Subject: About the base part externals change in RV-7F/7FL series

Applicable to: RV-7F/7FL series (except RV-7FLL series)

Figure 1 Details of the design change

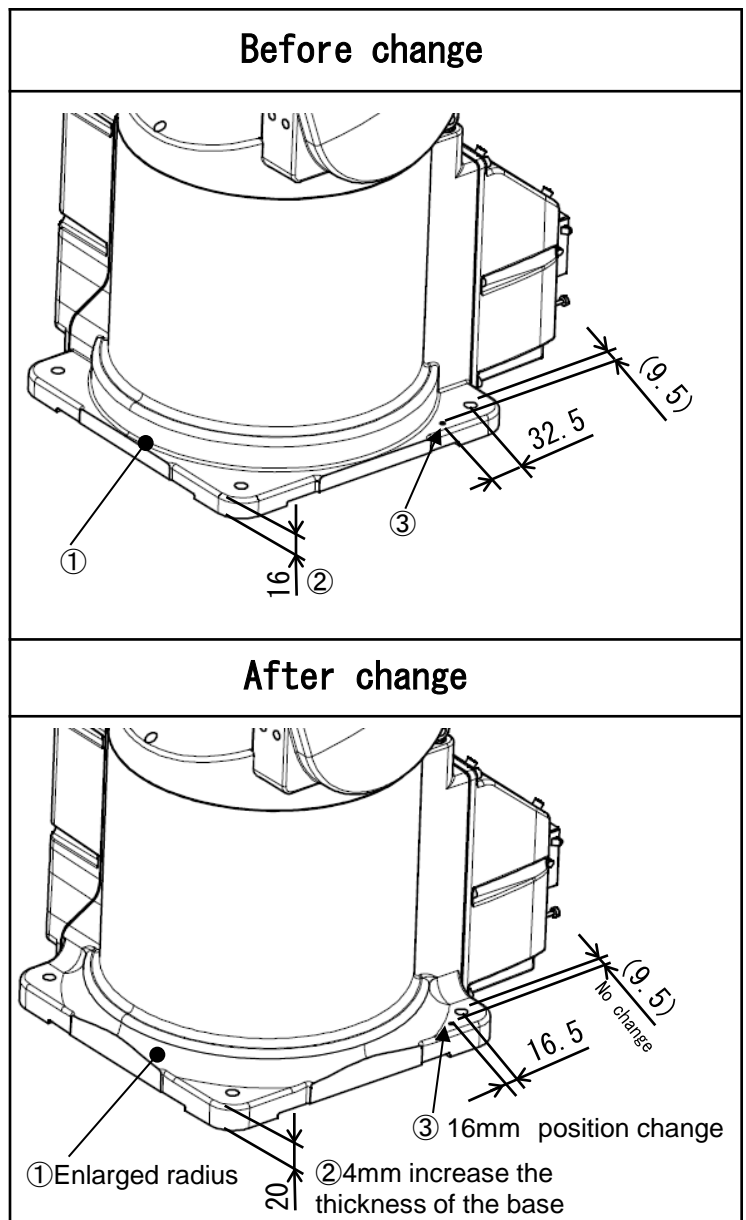
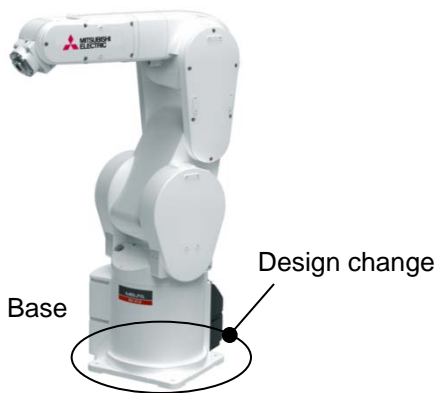
- ① Design change of the base.
- ② Change the thickness of the attachment area. ※1※2
- ③ Position change of the grounding screw.

※1
There is no change to the supplied installation bolts (M8X40).
If supplied bolts are not used please use appropriate bolts for installation.

※2
There is no change in height and installation dimensions.
